A RESOLUTION APPROVING THE BALTIMORE RAVINE SPECIFIC PLAN
(FILE: SPA 07-1)

Memorandum

To:	Auburn Planning Commission
From:	Reg Murray, Senior Planner <i>RM</i>
Date:	July 7, 2010
Subject:	Addendum Materials - Baltimore Ravine Specific Plan

Figure 5-6: Streets A, B, and D (Section D-D from Figure 5-1)

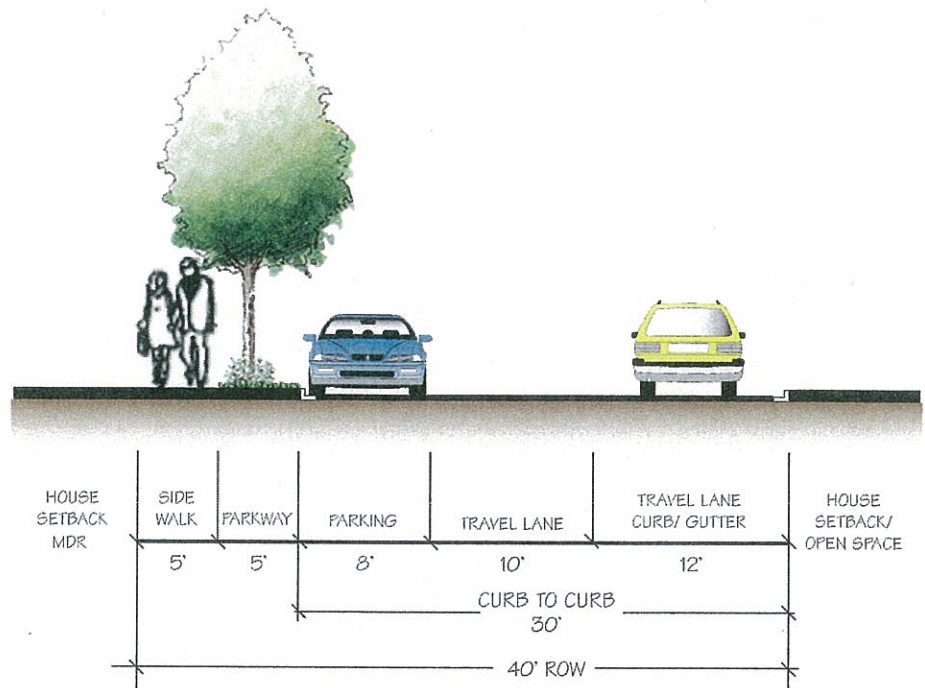
- **Street D** – Street D is a new street proposed to connect Plan Area 1 to Rogers Lane. The street section proposed for Streets A & B will also apply to Street D, with the exception that no landscape frontage will be provided where the street traverses open space (Parcel 89A).

Figure 5-10: Herdal Drive (Off-Site Improvement)

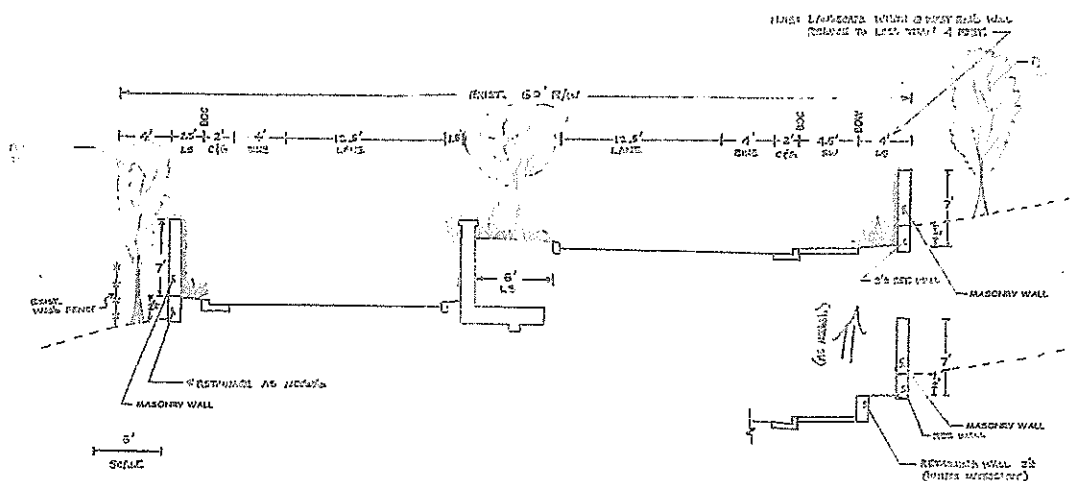
- **Herdal Cross-Sections** – The applicant’s original proposal for the extension of Herdal Drive involved a conventional road section. The applicant is now proposing a split-road section with a landscaped median and 7’ tall masonry walls on both the northern and southern sides of the roadway (see Chapter 5; Fig 5-10 attached).

- * **Herdal Drive** – The primary access point to the BRSP is provided through Plan Area 1 via the extension of Herdal Drive just outside the southeastern edge of the Specific Plan Area. This off-site improvement includes construction of a new bridge spanning the westbound UPRR line. This roadway has a 60'-wide right-of-way and includes two automobile travel lanes and bike lanes. The extension of Herdal Drive into Plan Area 1 uses a slightly-different design standard than the existing roadway, all of which is contained within the existing right-of-way (see Figure 5-10).

PROPOSED ROGERS LANE TYPICAL CROSS-SECTION

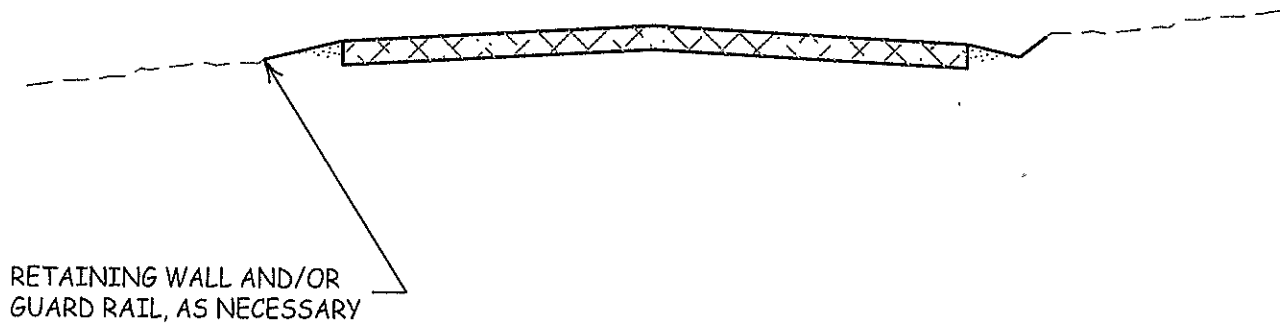
- **Rogers Lane cross section** – Since Rogers Lane is now the secondary access road, a cross section for Rogers Lane has been prepared for inclusion in BRSP Chapter 5 (see attached).

Revised Figure 3-1: Land Use Plan

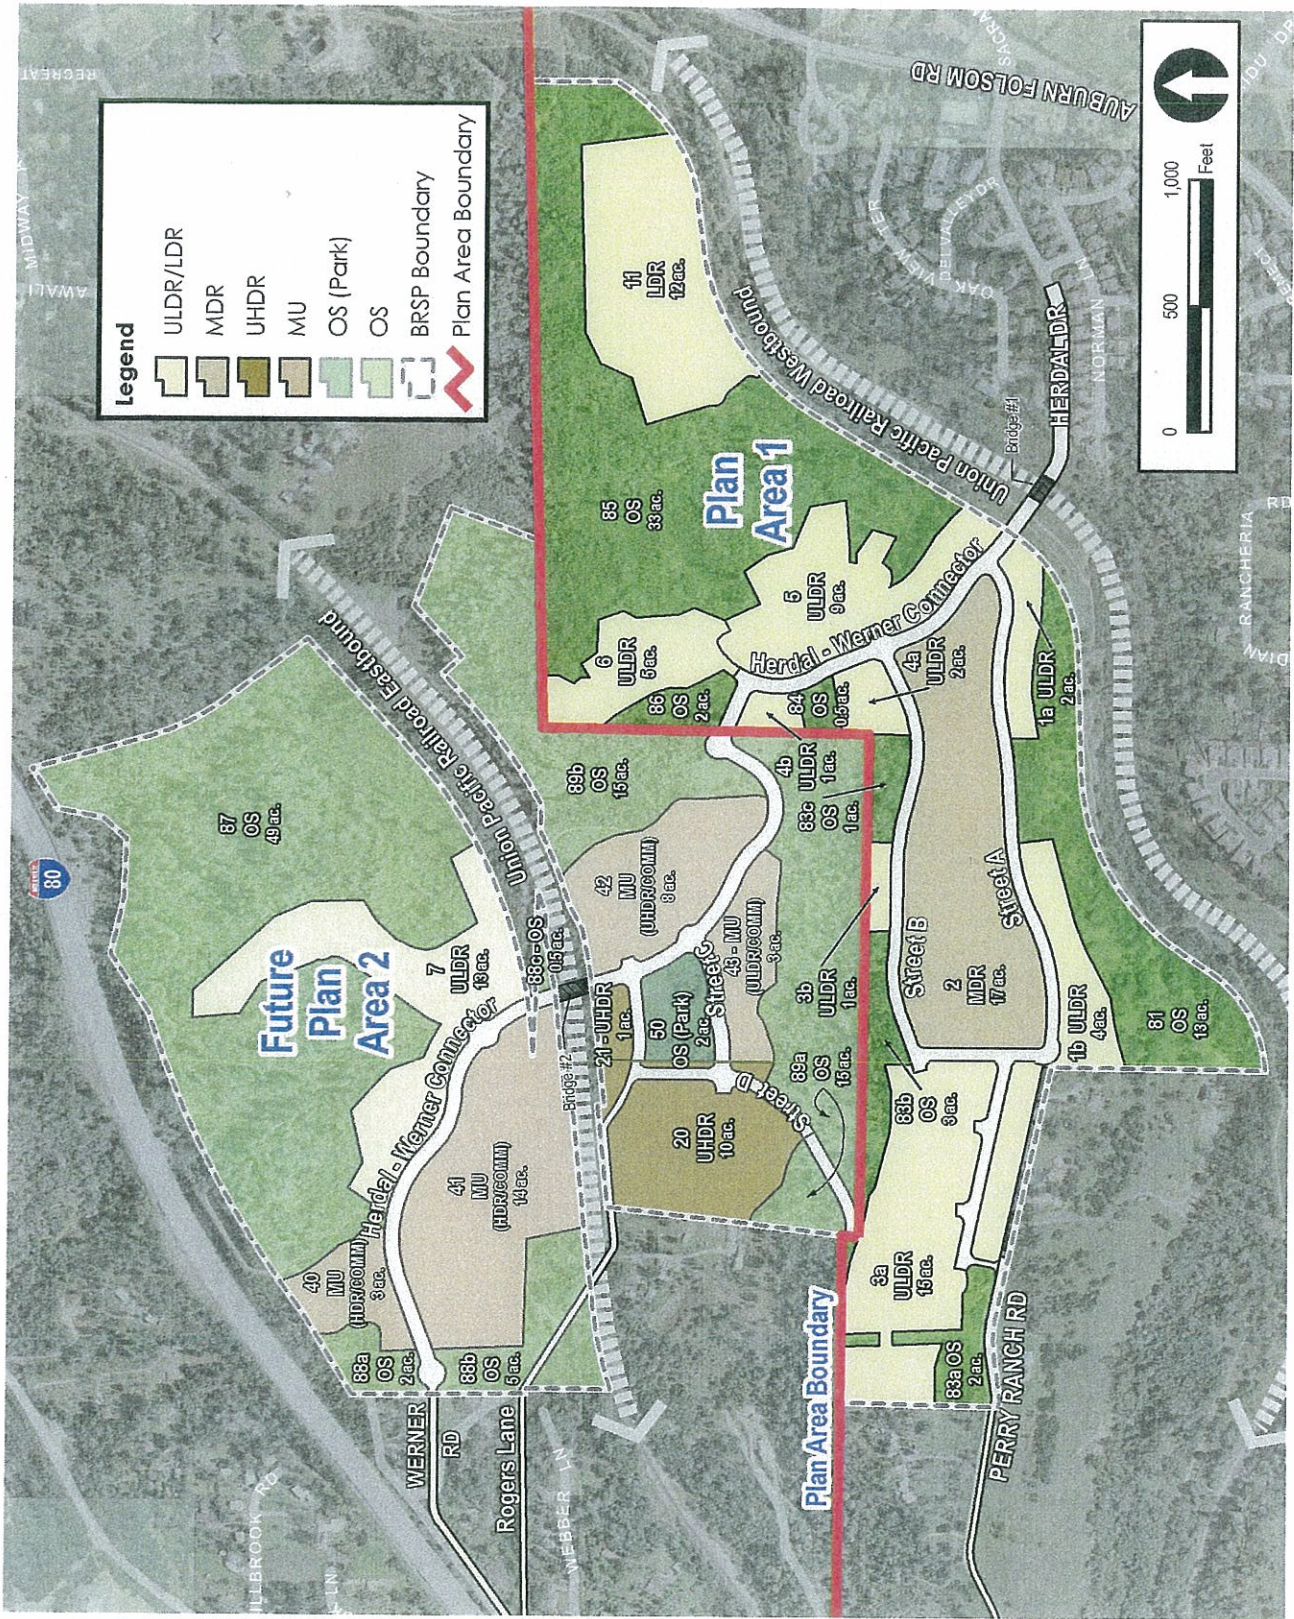
- **Land Use Figure** – The land use figure (Figure 3-1) has been revised to reflect the connection to Rogers Lane and the addition of Street D.
- **Land Use Summary Tables** – The acreage values in Tables 3-1 and 3-2 have been revised to reflect the changes associated with the Rogers Lane access and Street D.

Figure 3-1 attached to this memo has been revised to reflect the changes above. The other figures in the BRSP will be revised prior to the City Council review of the BRSP.

BALTIMORE RAVINE SPECIFIC PLAN
EMERGENCY VEHICLE ACCESS TO PERRY RANCH ROAD
MARCH 9, 2010

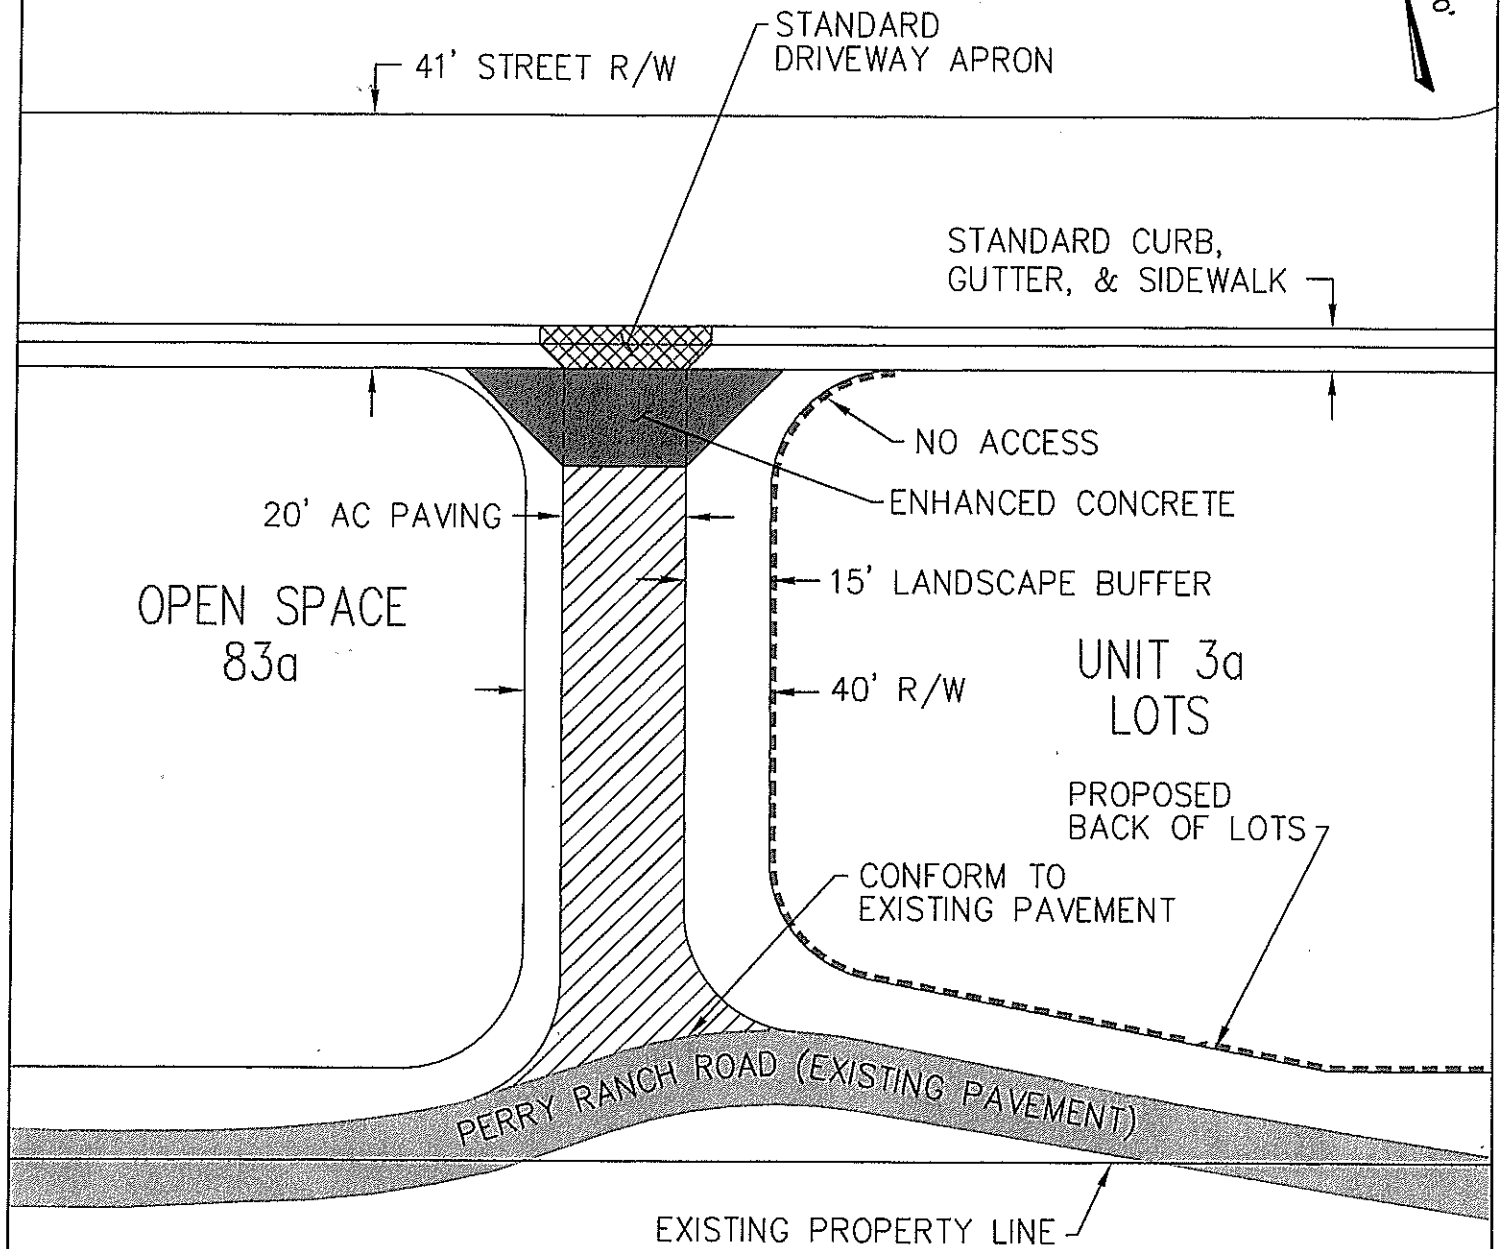
- **Design Guidelines** – The applicant is amending the Design Guidelines to include the following plans:
 - Emergency Vehicle Access – A plan is attached illustrating the proposed emergency vehicle access from Parcel 3A to Perry Ranch Road.

BALTIMORE RAVINE SPECIFIC PLAN LANDSCAPE BUFFER AT PERRY RANCH ROAD MARCH 10, 2010

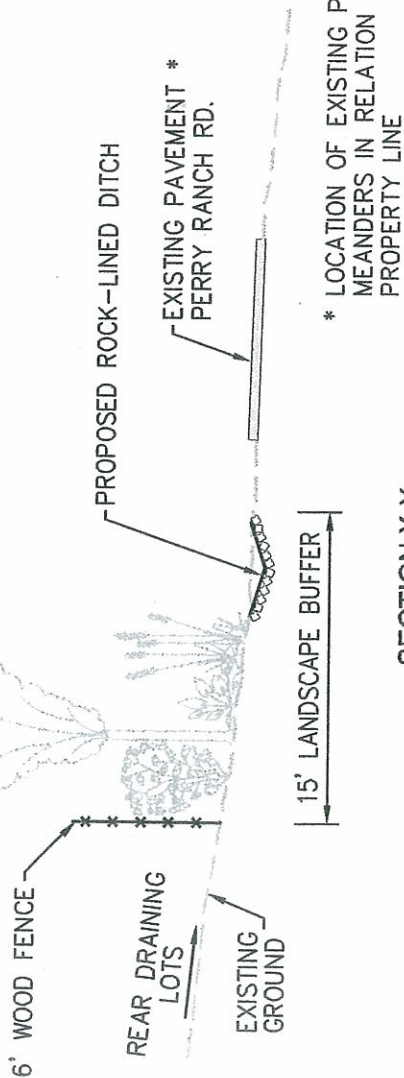
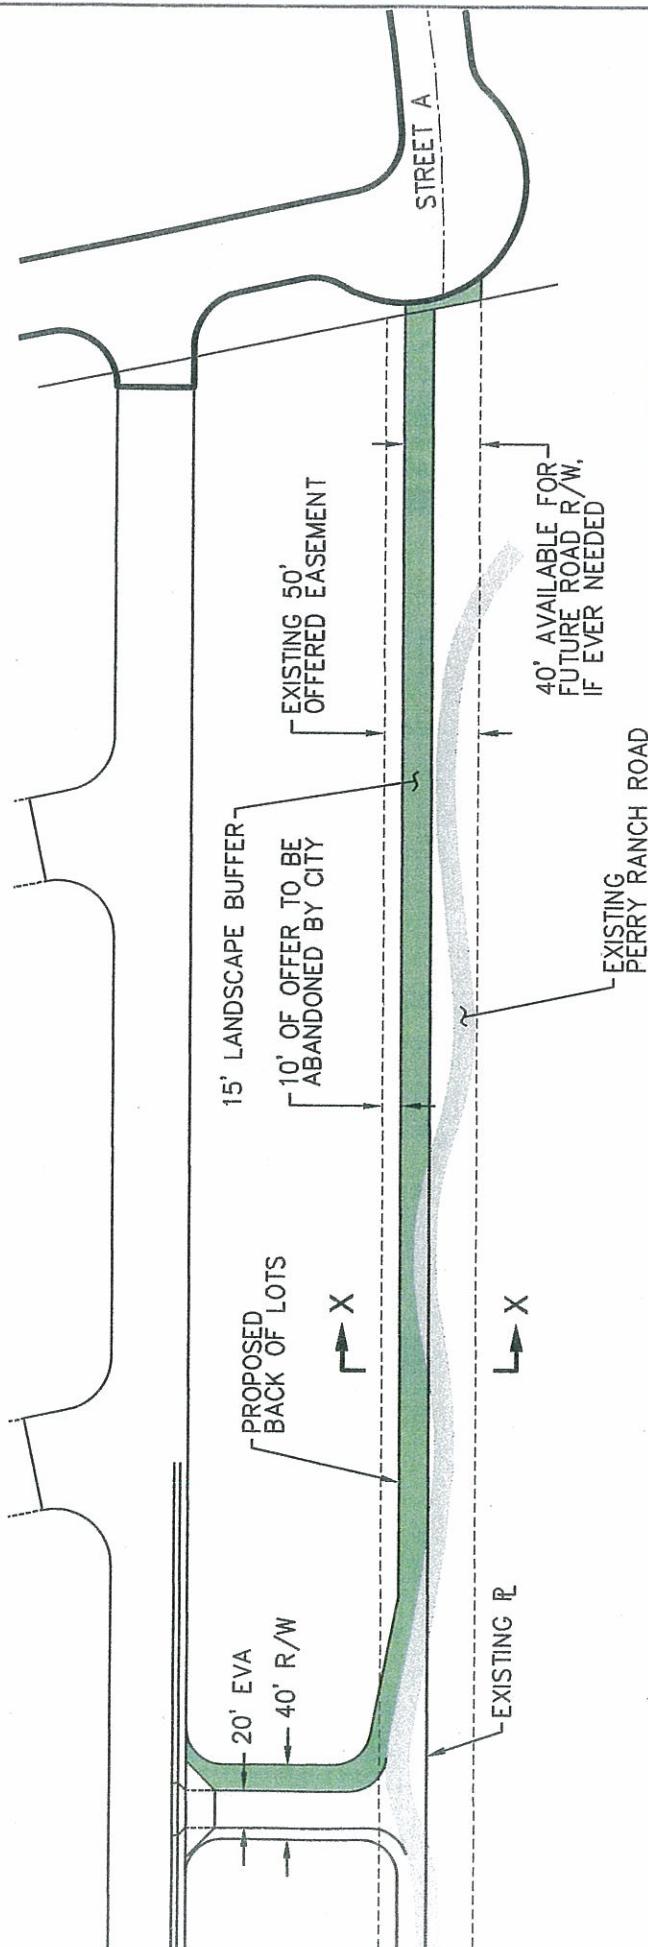
- Landscape Buffer – A plan is attached illustrating the proposed landscape buffer between Parcel 3A and Perry Ranch Road.
 - Schematic Lot Plan – A plan is attached illustrating the schematic lotting configuration and open space easement on the western side of Parcel 3A, abutting the Jackson property to the west.
